COUNTY COUNCIL'S RESPONSE TO CONSULTATION ON THE FOLLOWING DEVELOPMENT PROPOSAL

Application No: 21/01119/OUT

Proposal: Outline planning application for the re-development of the Banbury Oil Depot to include the demolition/removal of buildings and other structures associated with the oil depot use and the erection of up to 143 apartments and up to 166m² of community and/or retail and/or commercial space (Class Use E and/or F2) with all matters (relating to appearance landscaping, scale and layout) reserved except for access off Tramway Road

Location: Q8 Fuelcare, Tramway Road, Banbury

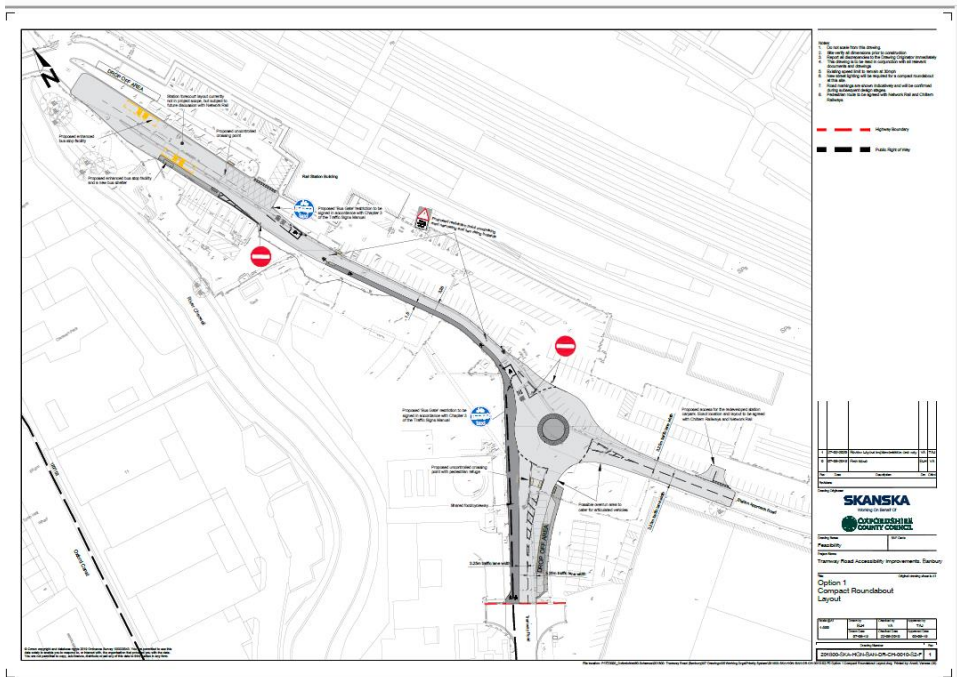
It should be noted that no Highway materials, construction methods, adoptable layouts and technical details have been approved at this stage. The detailed design and acceptable adoption standards will be subject to a full technical audit.

In terms of accessibility, the applicant is relying on the Tramway Road Scheme, however, it should be noted that we are still developing the scheme. For reference our current feasibility scheme (attached) should be used to inform the development proposals, acknowledging this will likely evolve given we are now progressing preliminary design.

It was disappointing that the applicant has not made any commitments to how it will support and facilitate the widening of the footway/cycleway within land under their control given our previous correspondence with the Applicant and Highway project Team Officers on this matter. The expected land required should also facilitate links to the wider regeneration area, town centre and railway station.

We therefore request the Applicant to provide us with further information (and commitment) to show how their proposal will support the widening of the footway/cycleway within land under their control to support suitable pedestrian and cycle facilities for their scheme and the aspirations of the Tramway Road scheme.

- The access should prioritise north/south movements by users of the footway/cycleway so this should be a raised access.
- The current arrangement would be unlikely to enable vehicles to turn left out of the access, radii should be suitable for this and tracking undertaken acknowledging the Tramway Road scheme provided (6m radii).
- Appropriate visibility splays should be shown and maintained.

Regarding the constrained nature of the link along Station Approach between the Station Car Park and the Certas Site, it is important that the developer facilitates the ability for the footway/cycleway to be widened from that of what we can currently achieve to not only support OCC's scheme but also access to and from their development parcel.
